**REZONING,
PLANNED UNIT DEVELOPMENT
SIDEWALK WAIVER &
SUBDIVISION STAFF REPORT****Date: October 18, 2007**

<u>APPLICANT NAME</u>	Orchard Baptist Church
<u>DEVELOPMENT NAME</u>	Orchard Baptist Church
<u>SUBDIVISION NAME</u>	Orchard Baptist Church Subdivision
<u>LOCATION</u>	6960 Overlook Road (Southeast corner of Overlook Road and Howells Ferry Road).
<u>CITY COUNCIL DISTRICT</u>	Council District 7
<u>AREA OF PROPERTY</u>	11 Lot / 7.0± Acres
<u>PRESENT ZONING</u>	R-1, Single-Family Residential & B-2, Neighborhood Business
<u>PROPOSED ZONING</u>	B-1, Buffer Business District
<u>CONTEMPLATED USE</u>	Rezoning from R-1, Single-Family Residential, and B-2, Neighborhood Business, to B-1, Buffer Business, to eliminate split zoning in a proposed one-lot subdivision for a church. Planned Unit Development Approval to allow four buildings on a single building site, and Subdivision approval to create one legal lot of record.
<u>REASON FOR REZONING</u>	The reason for rezoning provided by the applicant reads as follows: to eliminate split zoning of a proposed one-lot subdivision

SITE PLAN

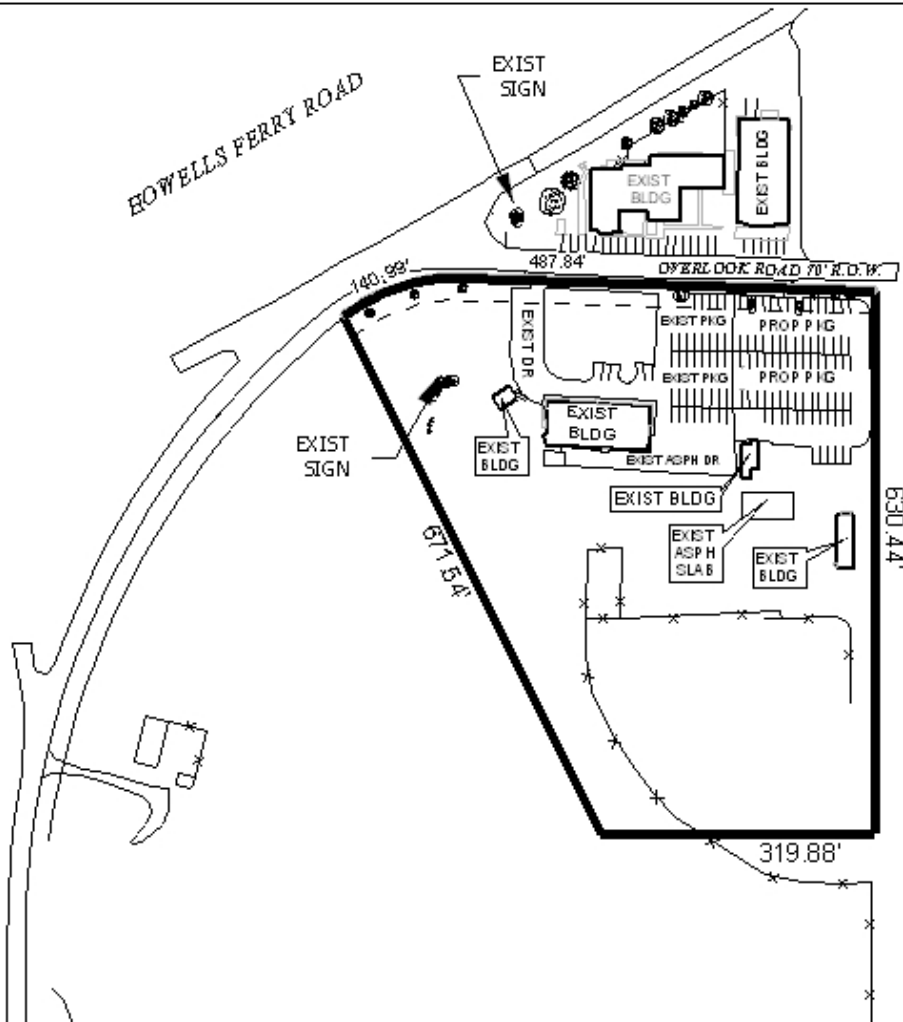
The revised site plan illustrates a proposed expansion of parking facilities, which will provide a total of 116 parking spaces on site. The plan indicates that the seating for the church is 500, requiring a minimum of 125 parking spaces. Given the layout of the proposed expansion, it appears that an additional 9 spaces could easily be accommodated in the southern portion of the expanded facilities.

Another issue is that the plan reflects a 320'± continuous curb cut. As shown on the plan, the curb cut would effectively allow direct ingress and egress for 11 parking spaces, and only has an 18-20' wide "formal" entrance into the parking facility. While it appears that this access may be existing, the extensive expansion to the parking facility should be adequate to require modifications to the curb cut and entrances.

The applicant has submitted a revised plan that reflects the church properties across Overlook Road, however there are still several issues that have not been addressed. The revised plan does not accurately depict property lines for the church property on the North side of Overlook Road; does not include revisions to access for the property on the South side of Overlook Road, as were conditioned by the rezoning and subdivision approvals; does not include additional parking spaces to meet minimum requirements; proposes parking spaces that are not accessible due to a power pole and guy wire. Additionally, as noted for the November 15th meeting, the site on the North side of Overlook consists of multiple parcels and should have had a subdivision application.

Additionally, the property on the North side of Overlook is shown to have 20+ parking spaces that appear to be located at least partially in the right-of-way, or at a minimum have all their maneuvering in the right-of-way. As these parking facilities are existing, removal at this time may not be justified based on the scale of the project before the Commission. However, any future expansion/construction on either site should require elimination of those spaces, including removal of paving material, installation of appropriate curb cuts (to be approved by Traffic Engineering), installation of landscape materials and construction of a city standard sidewalk.

Based on the applicant's failure to revise the plan as previously indicated – or provide justification not to do so, and the fact that PUD approval is site plan specific, there is little to no option but to recommended yet another holdover or denial.
